Loreto Kirribilli Response to Submission

Concept Master plan and Stage 1

Project Name		Loreto Kirribilli - Concept Master plan and Stage 1	
Project Code		LKMP	
Document Name		Architectural Design Statement	
Document ID		LKMP Response to Submission	
Revision	Date	Comment	Approved
00	29/01/18	RTS Submission	EC

5.0 Figure 4 Bicycle Parking

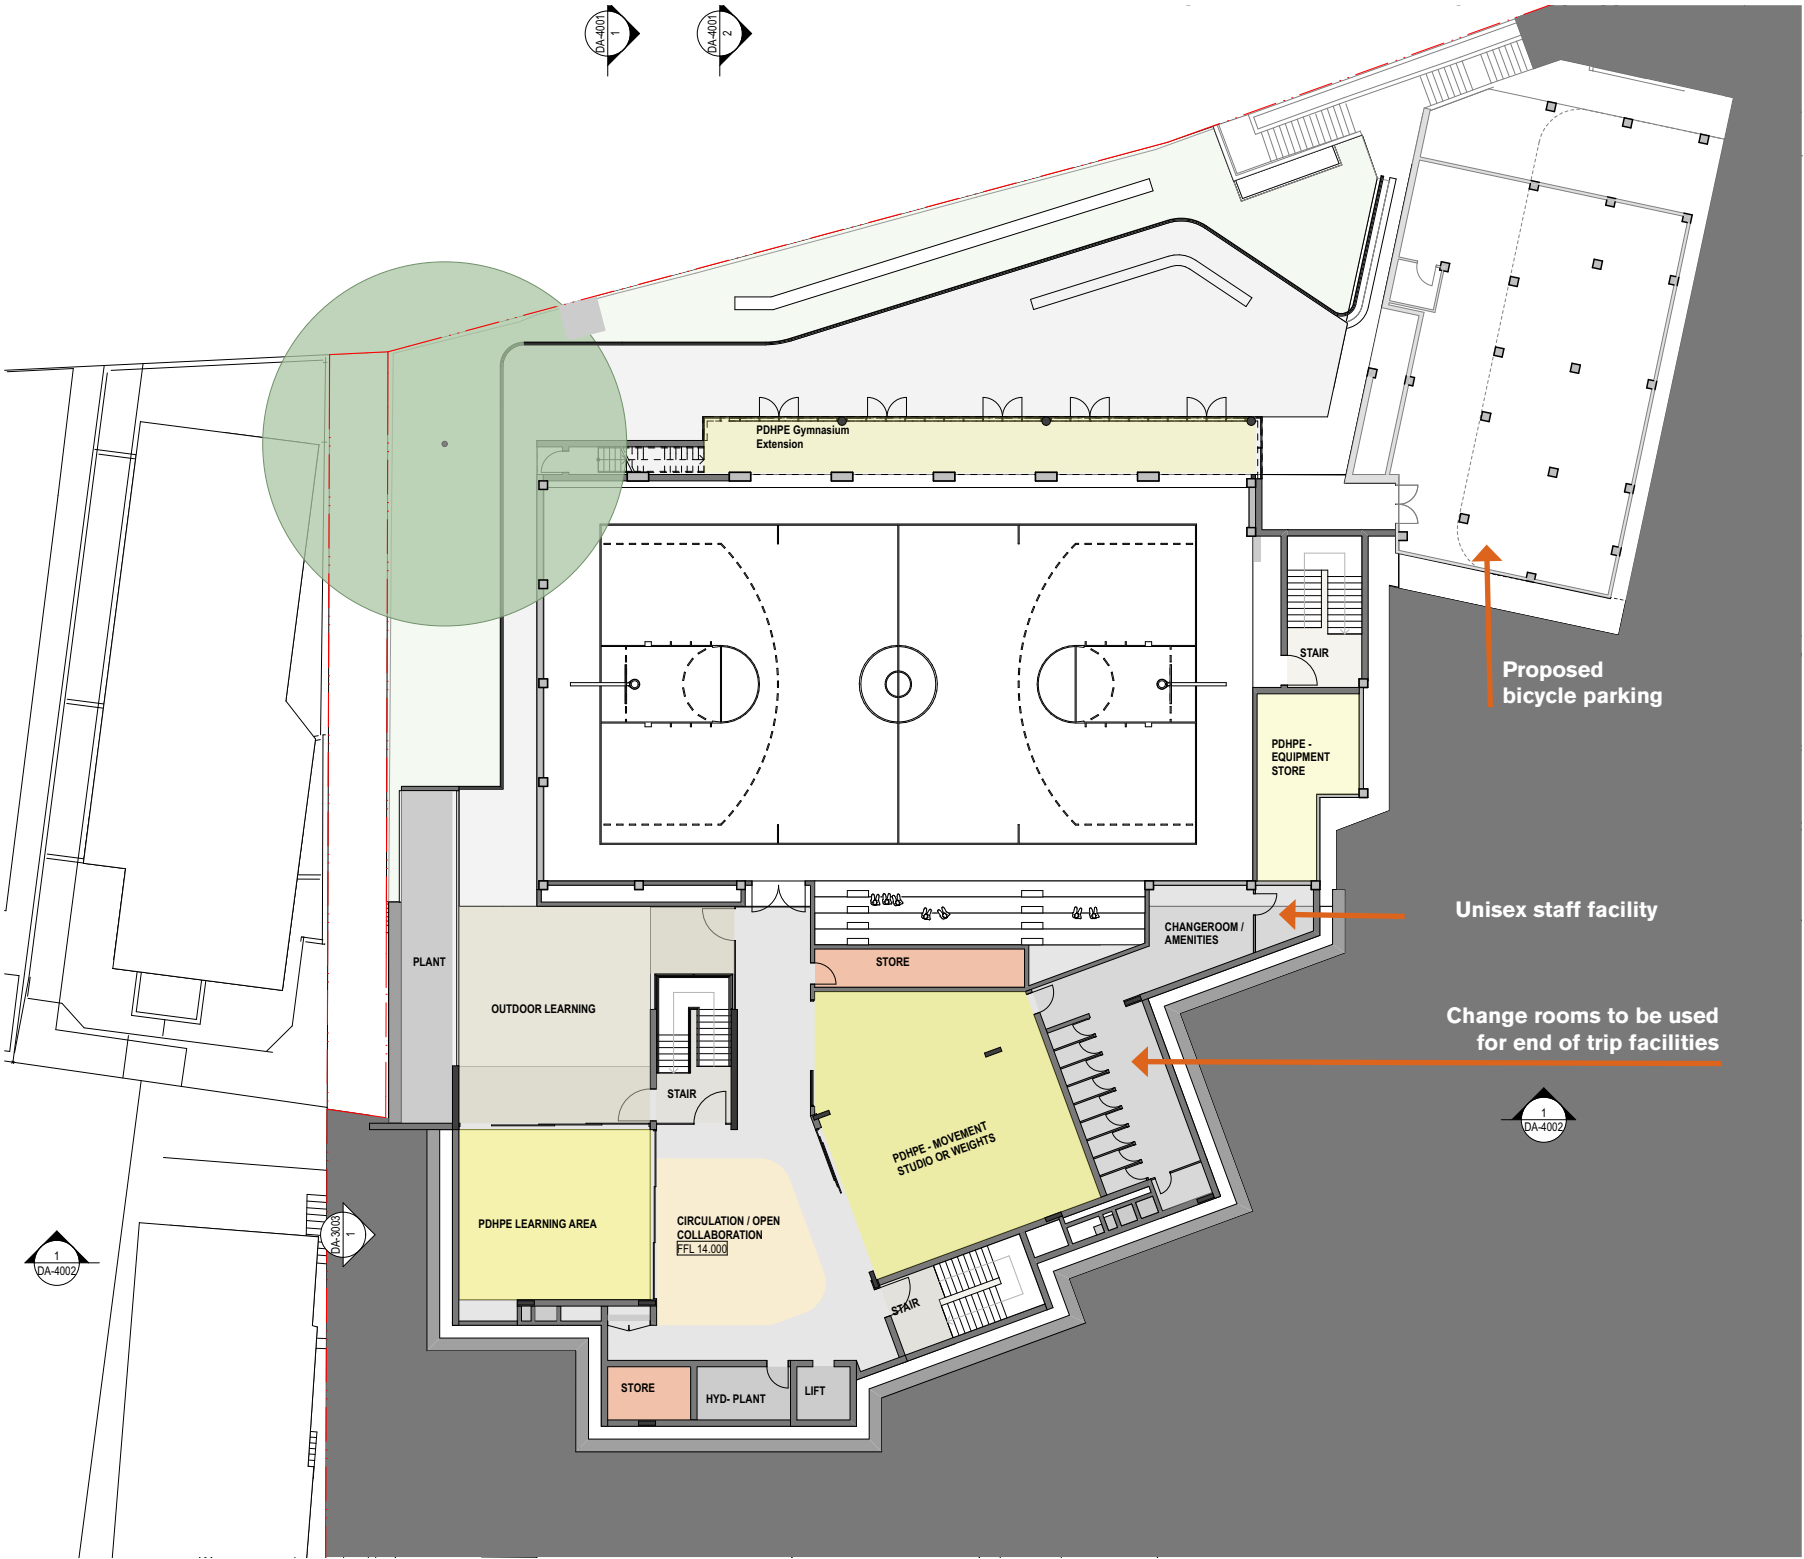
No bicycle parking is provided. The transport and traffic survey showed that no students or staff arrive at school by bicycle, and that the school is very well serviced by public transport. However due to the density of the surrounding residential area street parking is in high demand and therefore all car trips and parking to the school should be discouraged. Bicycle parking and end of trip facilities should be provided.

Approximately 20 bicycle parking spaces are able to be provided in the existing sports storage area on the lower ground level of Centenary Hall with the end of trip facilities within the adjacent Lower Ground level of the New Learning Hub. Access is able to be provided directly off Elamang Avenue via a stair ramp on the existing stairs.

W21, W22 Views

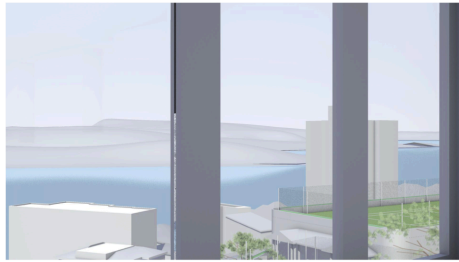
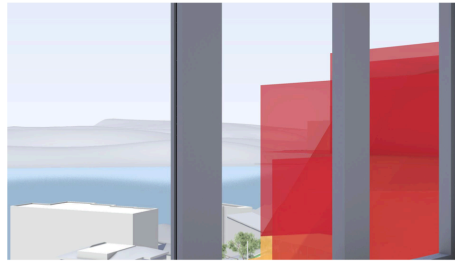
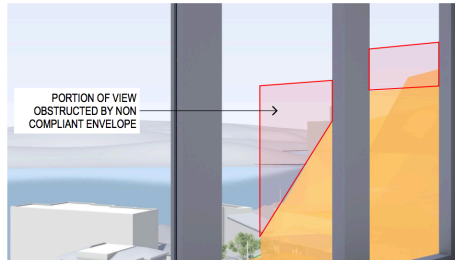
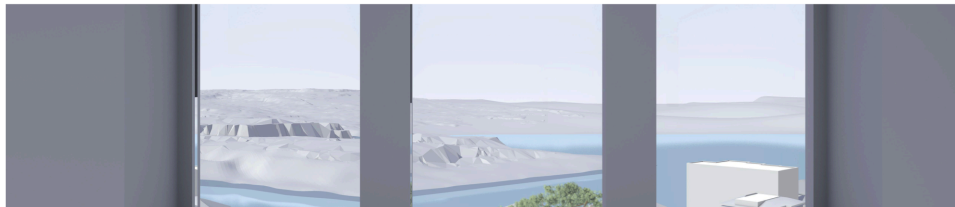
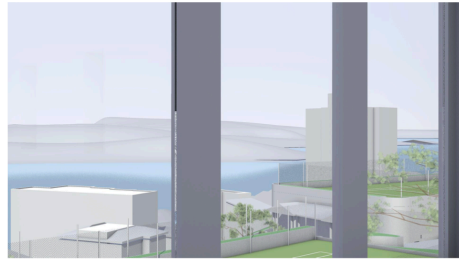
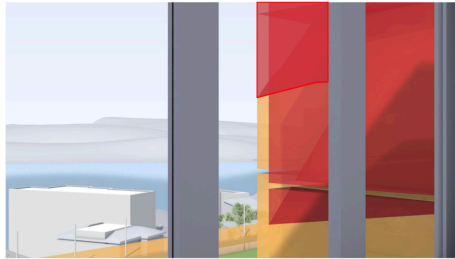
**Note 2: The impact of the proposal to the 2 apartments above i.e. W21 & 22 is similar; about a 50% reduction of views, but is due to the non-compliance. Refer to Figure 3 below.*

In regard to the view from W21, W22 and W23 views were tested from a number of angles to assess the percentage of overall view loss. Refer to the below image and attached drawing sheet SKMP-60.1/SKMP-60.2 for further details. W21 is taken from a worse case view point looking obliquely across the school site however when looking directly out of the window (Total View) there is no impact to the existing views. Also to note as illustrated below the view obstruction attributed by the non complying portion (shown in red) is considered to be relatively minor when considering both the total view and the oblique view and is the result of the non compliance with the DCP height plane, rather than the 12m LEP height control. W21 shows a small portion of harbour view loss and W22 shows small portion of sky loss from the non compliant envelope. Therefore the overall percentage view loss is considered to be minor.

Images from SKMP-60.3 - W23

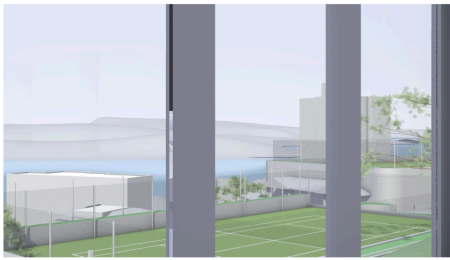
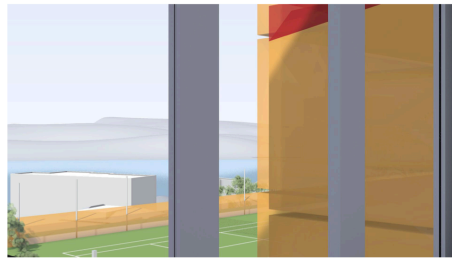
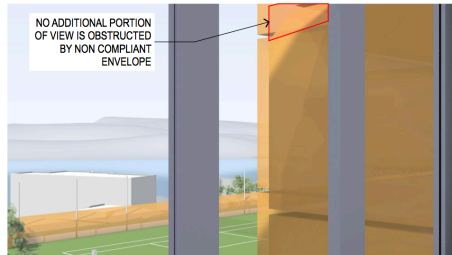
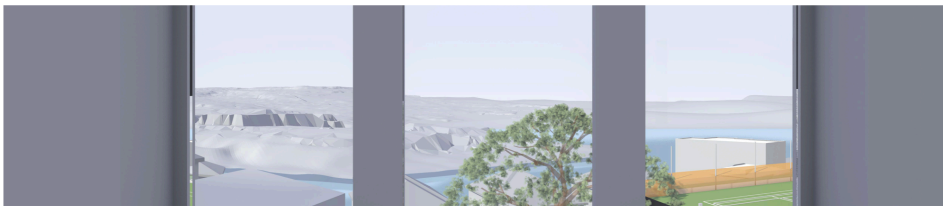
**Note 1: The significant impact of the proposal (compliant or not); about a 50% reduction of views.*

The view loss in this view is attributed to the compliant portion of the proposed building envelope. Similar to above and in reference to the below images and attached drawing SKMP-60.3 when considering both the total view and the oblique view the impact of the compliant envelope is considered minor.

Image from View Impact Assessment Drawing MP-61111 - W26 - Before & After View

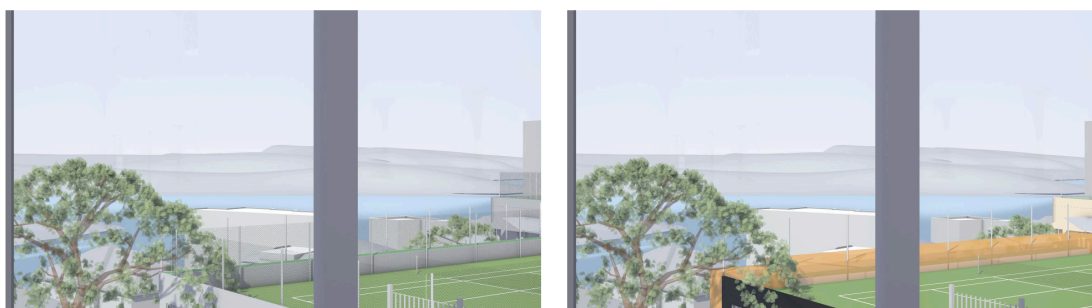
Picture 5 – Existing view of the harbour, forests & sky from inside the extended living / dining room
(Ref W26 on View Analysis plans)

Picture 5 page 13 incorrectly references the view from window W26 in figure 4. Refer below to the correct reference for the W26 view from Drawing sheet MP-6111. From this image the proposed development envelope for the gymnasium extension does not obstruct the existing harbour views. The photograph provided (Picture 5) also further illustrates this as the existing tennis court is not as visible and also identifies a greater extent of harbour views than illustrated in the model views.
